NUCLEAR REGULATORY COMMISSION

Title: **Advisory Committee on Reactor Safeguards
Non-Power Production and Utilization Facilities**

Date: Friday, May 6, 2022

Main Production Facility Structure

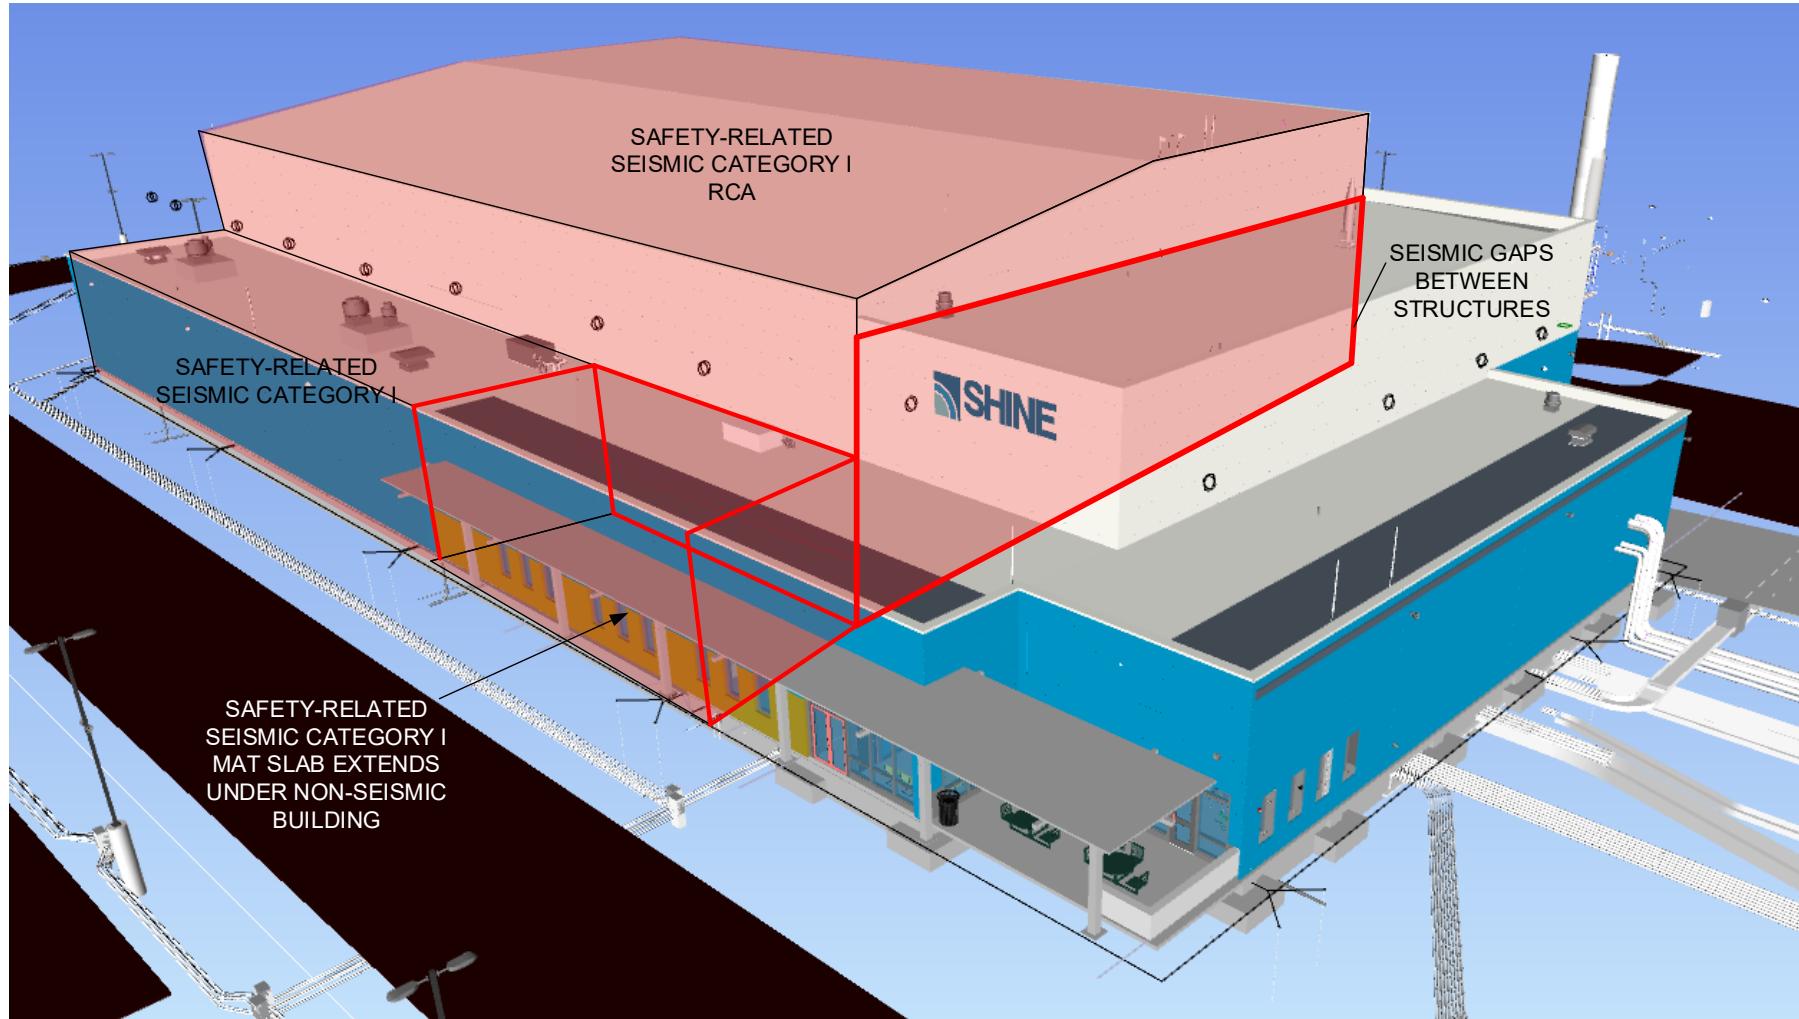
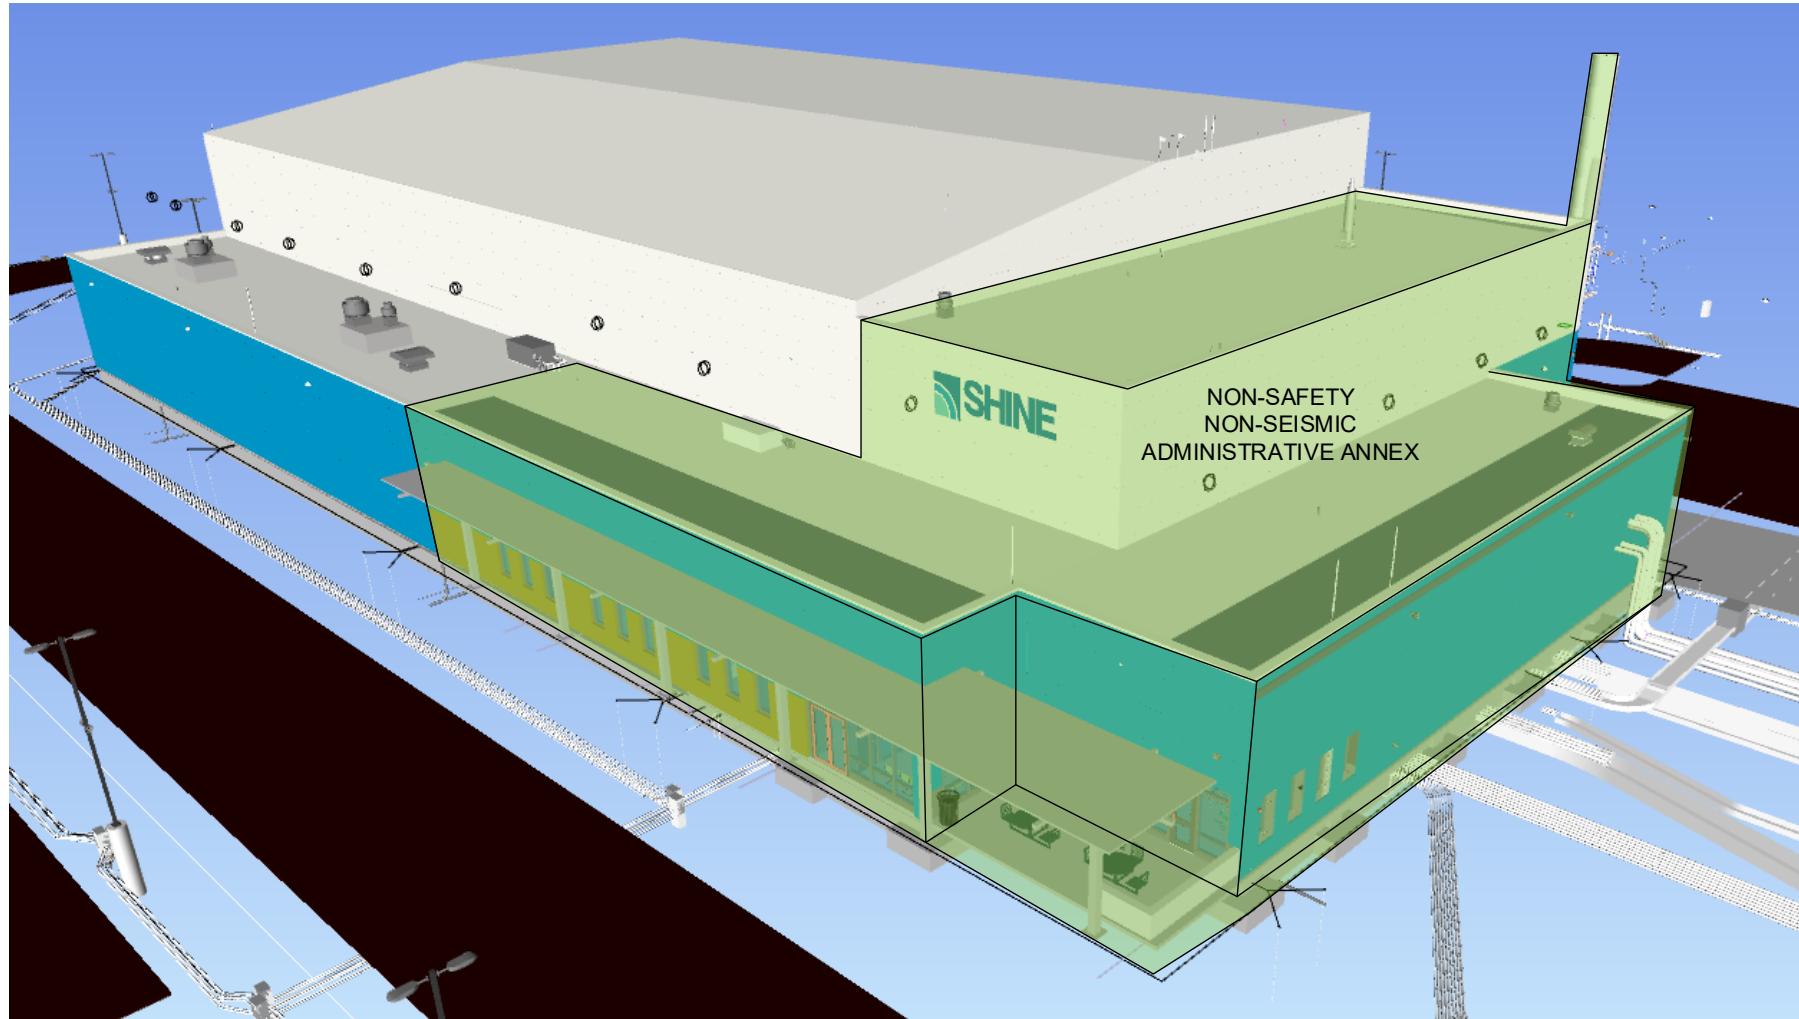
11 DR. BLEY: This is Dennis Bley. You've
12 talked several times about the seismic gap and I was
13 thinking back to a nuclear power plant quite a few
14 years ago that was designed with such a gap. There
15 had always been a concern in the seismic area that
16 maybe you fall off a cliff once you get past the
17 design-basis and all of a sudden everything starts to
18 fail. The only place I ever saw that happen; we were
19 doing risk assessments at the time, was a plant that
20 had a gap that was I guess you could say just set to
21 the design-basis. If the earthquake went a little
22 above the design-basis, the buildings interacted and
23 you had substantial problems developing.

3 MR. ANDERSON: It's not a situation that
4 we've analyzed. The way we sized the gap is we've
5 checked the maximum displacements of the safety-
6 related structure and we added that --

9 MR. ANDERSON: That's correct. And the
10 maximum displacements of the non-safety-related
11 structure for the -- for its design-basis earthquake,
12 which is simply the ASCE 7/IBC sort of commercial
13 design earthquake. And we've added those two
14 displacements together and included some margin on top
15 of that to make sure that they're --

Figure 8a2.1-1 – Electrical Distribution System (Simplified)

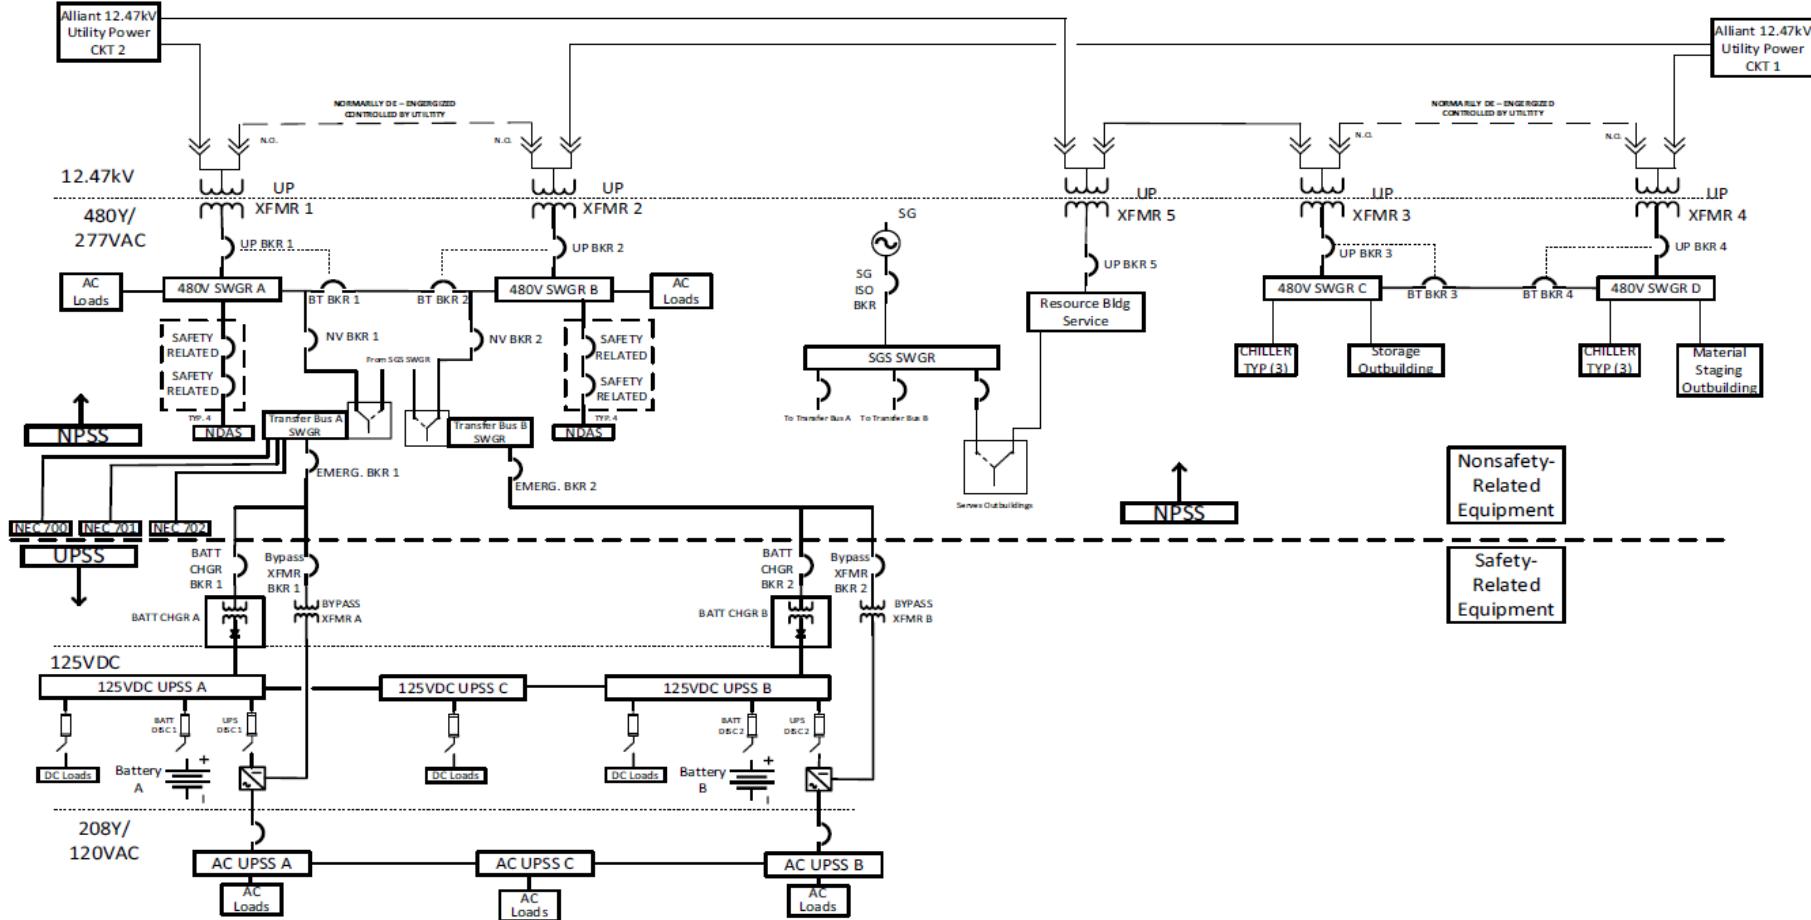
3 MEMBER BROWN: Can we go back? This is
4 Charlie Brown. I had a -- we popped up and we were
5 muted. So, I had some questions on the figures.

16 MEMBER BROWN: And the loads on C are then
17 auctioneered between A or B. Is that correct, or is
18 that a transfer switch also?

21 The one last question on this is up on the
22 DT breaker 1 and 2. Those are, obviously you do not
23 want those closed at the same time.

7 Your power comes from Alliant, and you
8 show two different feeds coming out of a little box.
9 So, effectively if you lose Alliant, you lose all AC
10 power.

19 MR. THOMAS: Correct. So, let me start
20 with the AC connection, that's easiest to explain.
21 That is the transfer switch. The power is either from
22 A or from B.

13 MR. THOMAS: Actually, if we have that
14 total loss of power and go into plant shutdown and the
15 UPSS applies, you acquire them for safe shut down of
16 the plant.

23 MR. THOMAS: We go into plant shutdown.
24 We don't try to keep operating. So, the UPS system
25 provides enough power to safely shut down the plant.
